**Cnr Reserve & Balcombe Road, Beaumaris**

## **Arboricultural Construction Impact Assessment**

**Thursday, 24 November 2016**

Ref: 4068 161208 CIR Stewart Cnr Reserve & Balcombe Beaumaris Rds

Figure 14: Tree with potential to be retained at Reserve Road Frontage

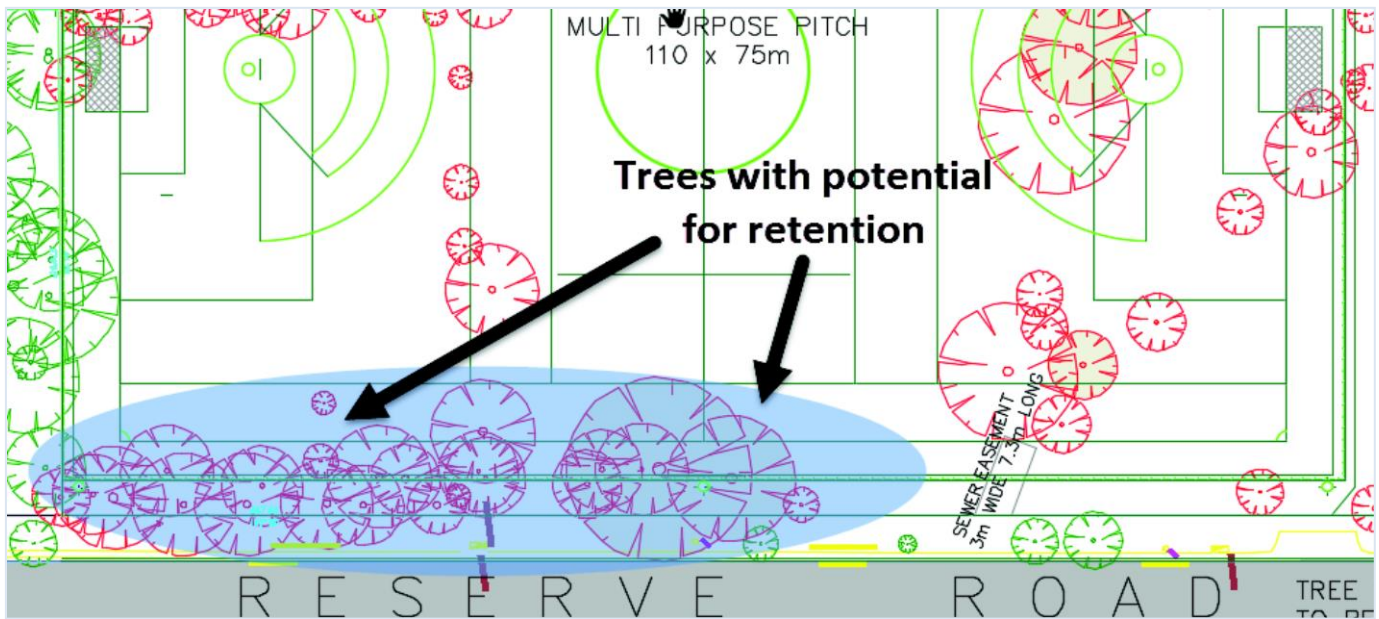
It is proposed that a multi-purpose pitch be constructed immediately to the west of or directly upon these trees (Figure 14).f

No data has been recorded detailing the dimensions and TPZ measurements of these trees. As such precise set-back requirements could not be determined to establish the distances required to ensure the viability of each tree. However based on a visual estimation of tree sizes and the locations of the trees shaded blue in Figure 14, a *minimum* set-back of 3 metres from the currently proposed eastern border of the multi-purpose pitch would be required to retain the smaller trees.
